SERVICE BULLETIN

Classification:	Reference:	Date:
BT20-007	NTB20-026	March 31, 2020

2005-2019 FRONTIER; HIGH-MOUNTED STOP LAMP SERVICE PART

APPLIED VEHICLES: 2005-2019 Frontier (D40)

Figure 1

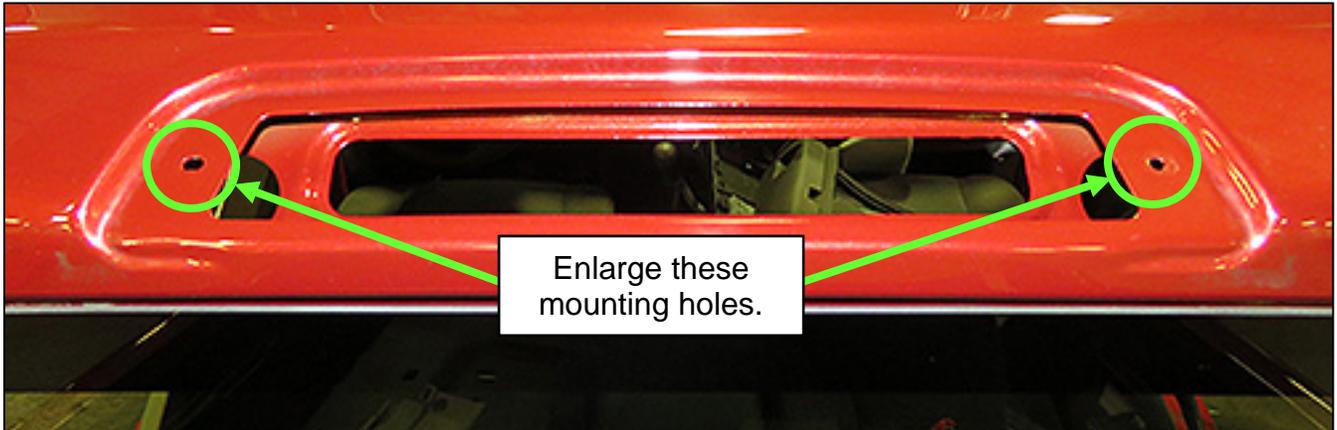
The mounting stud diameter for the high-mounted stop lamp service part has changed from 5 mm to a 6 mm.

If for any reason the high-mounted stop lamp needs to be replaced, the mounting hole will need to be enlarged to 6.5 mm (¼ inch) as follows:

1. Remove the high-mounted stop lamp.
 - For high-mounted stop lamp removal, refer to the Electronic Service Manual: Section **DRIVER CONTROLS > EXTERIOR LIGHTING SYSTEM > REMOVAL AND INSTALLATION > STOP LAMP**.
2. Enlarge the high-mounted stop lamp's mounting holes (see Figure 1 on page 2) using a 6.5 mm (¼ inch) drill bit.

NOTICE To avoid damage to the vehicle, apply light pressure to the drill while drilling. Excessive force may cause the drill bit to penetrate too far and damage the headliner.
3. Apply touch-up paint to the mounting holes to protect the bare metal.
4. Install the new high-mounted stop lamp using M6 mounting nuts. Refer to the **PARTS INFORMATION** on page 2.
